# Accessibility Survey

## City of Downey Mitla Avenue - De Palma Street To End

Date of Inspection  
4/21/2017

Prepared By  
**Disability Access Consultants**  
(800) 743-7067

**Change In Level South Of Benares Street @ 33.946274821780, -118.158657699823**

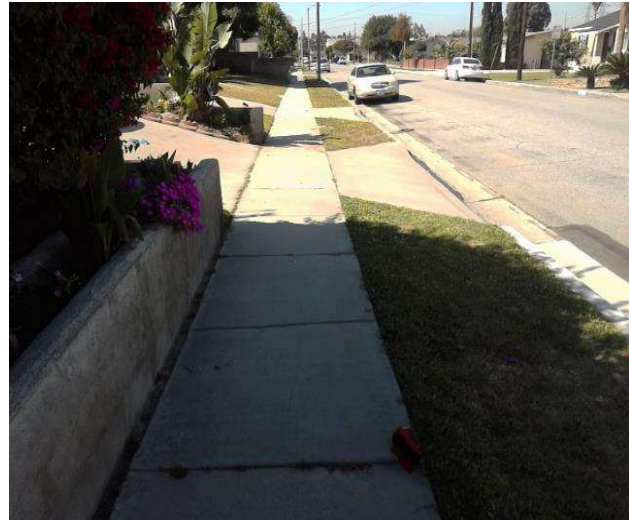
There is a change in elevation greater than recommended value.

**On-Site Finding** 0.75 inches

Ensure that the change in elevation is within the recommended value.

Recommendation Up to 0.25 inches

**Change In Level North Of Luxor Street @ 33.945781970122, -118.159215599298**

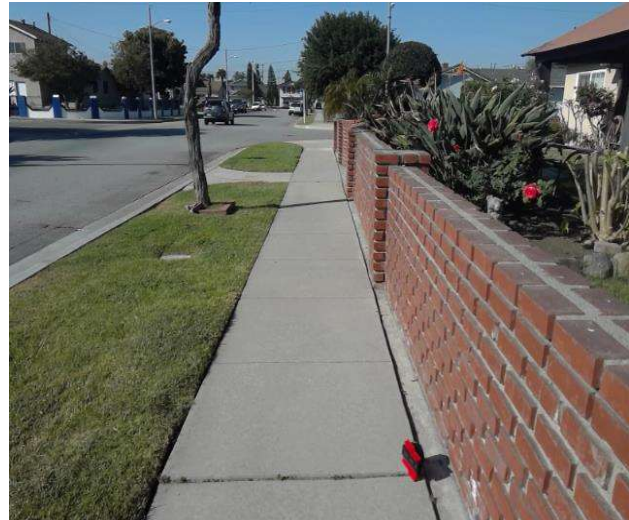
There is a change in elevation greater than recommended value.

**On-Site Finding** 0.62 inches

Ensure that the change in elevation is within the recommended value.

Recommendation Up to 0.25 inches

**Sidewalk South Of End @ 33.947922460893, -118.157492286**

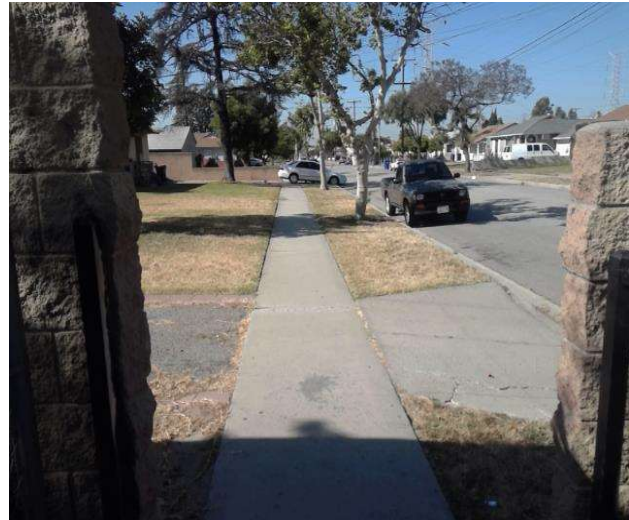
Sidewalk cross slope is not compliant.

**On-Site Finding** 4.30 percent for 13.00 feet

Repave the sidewalk surface with the recommended cross slope.

Recommendation Up to 2.08 percent

**Sidewalk South Of Luxor Street @ 33.945395919539, -118.159283995628**

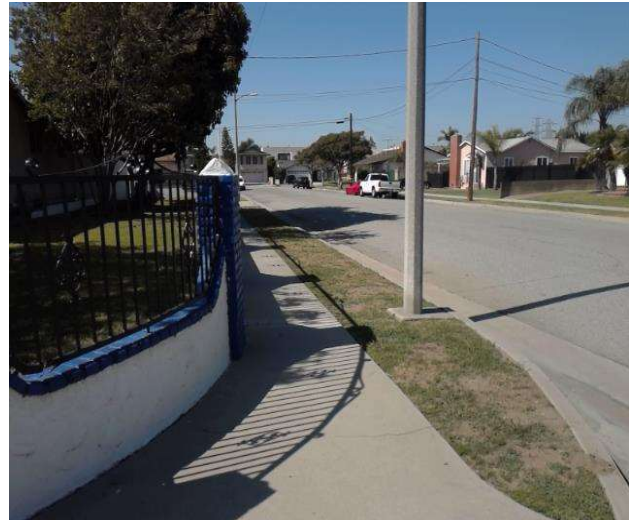
Sidewalk does not have enough width.

**On-Site Finding** 45.00 inches for 69.00 feet

Widen the sidewalk to the recommended value.

Recommendation At least 48.00 inches

**Sidewalk South Of Luxor Street @ 33.945395919539, -118.159283995628**

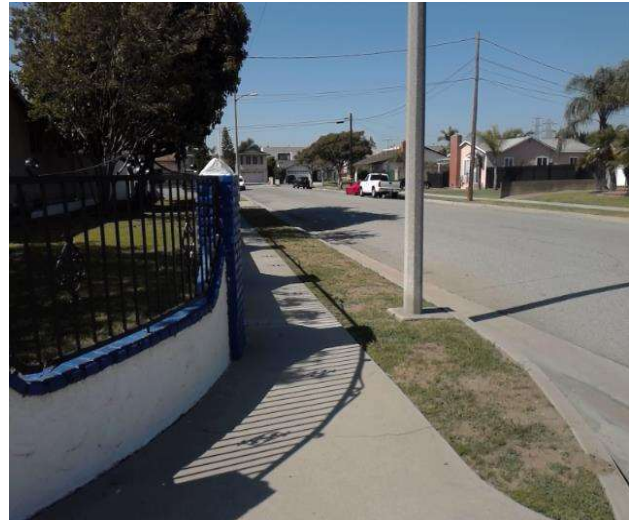
Sidewalk cross slope is not compliant.

**On-Site Finding** 4.60 percent for 49.00 feet

Repave the sidewalk surface with the recommended cross slope.

Recommendation Up to 2.08 percent
